Car Stereo Service Bulletin

Model: CDX-5040/5080

No. 212

Subject: Part Number Addition: Walkman Input Dust Cover

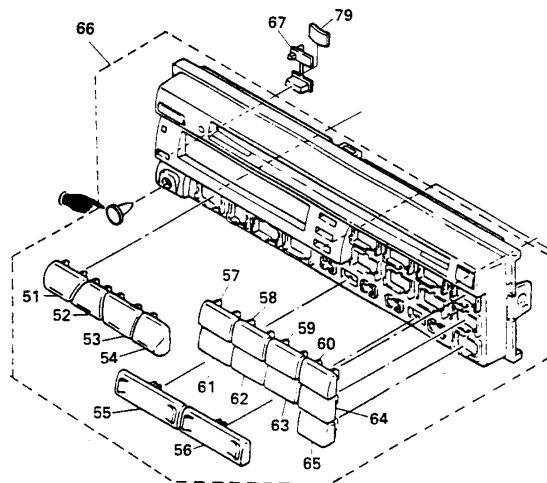
The part number for the walkman input jack dust cover was omitted from the Service Manual.

Please add the following part information to your Service Manual:

DESCRIPTION	PART NUMBER
COVER, (WM)	3-368-115-01
